Request for Class II Permissive Change

FCC ID: 2ALZM-SV55216

Subject: FCC Class permission change for FCC ID: 2ALZM-SV55216

This project is a CIIPC submission to our product: Smart phone, model: SV55216, the device is identical to the previous certified except for the changes as below:

Receiver have different marketing;

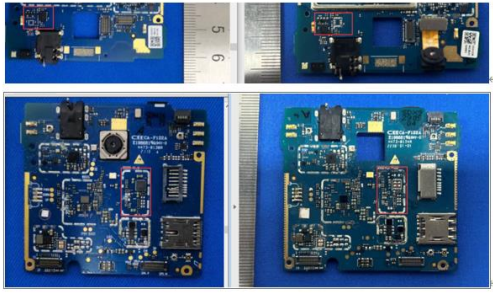
Supplier1 (Original)	supplier2 (Variant)
SDRP0612HJ05-02-F1	SDRP0612HJ05-02-F1-1
Same specifications
